Project/File: Milano PUD Traffic- 215811383

Reference: Milano Response to Gary Scott's Statement (22-40SP)

Reference: Milano PUD TIA ARC Review

Alex Roark Engineering has reviewed the Transportation Impact Analysis for the proposed Milano PUD Commercial prepared by Stantec dated October 2023, and we offer the following comments.

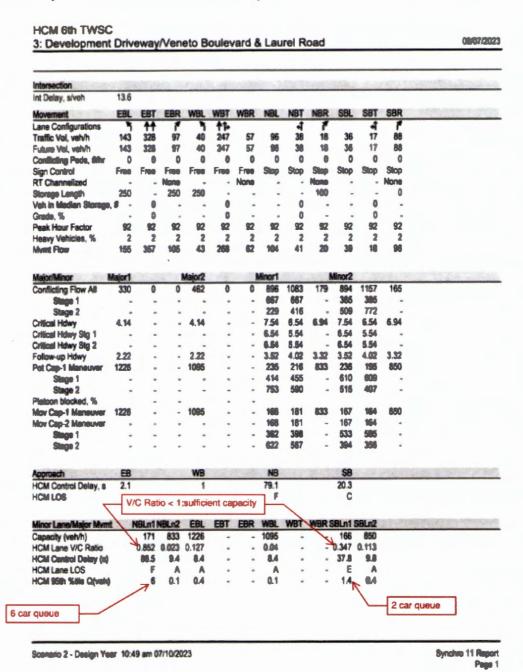
1. Under LDR 86-23(m)(3) the city council should consider, "Ingress and egress to the development and proposed structures thereon, with particular reference to automotive and pedestrian safety...:

The proposed ingress and egress at each proposed driveway were submitted to Sarasota County, who is the operating and maintaining agency for Laurel Road, in the form of administrative variances for full median openings on Laurel Road and on Jacaranda Boulevard (October 8, 2021) and for a traffic signal at the Laurel/Veneto intersection (October 4, 2022). The full median openings were approved February 11, 2022. While I issued my opinion in the Traffic Signal Administrative Variance, that the Laurel/Veneto intersection would be safer with a traffic signal, the Traffic Signal Administrative Variance was denied by Sarasota County on January 10, 2023.
